Permit of Authorization to Construct an On-Site Sewage Facility Permit Valid For One Year From Date Issued

Permit Number: 119033

OSSF DESIGN

Thank you for your submission. We have reviewed the planning materials for the referenced permit application, and unfortunately, they are insufficient. To proceed with processing this permit, we require the following:

SITE PLAN & OSSF DESIGN:

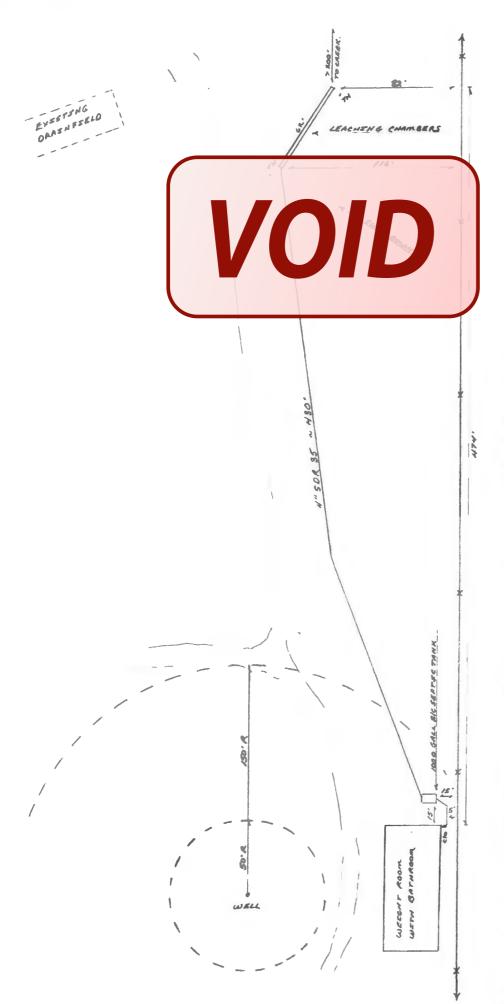
Subject: Text Box Page Label: 5

Status: Color: ■ Layer: Space: More details on structure. Where are the figures for this system coming from in accordance to the structure.

Table III as well.

*Table 3 does not specifically reference "weight room with bathroom" for wastewater calculations. The weight room has no living area, and the bathroom contains only a toilet and a sink, no shower. There are no kitchens or washing machines. The closest reference in Table 3 would be "factories per person per shift" which lists the flow at 12 gpd/person. There will be potentially 2 people using this facility each day for a total of 24 gpd. The 30 gpd design Q uses a safety factor of 1.25 (Q).
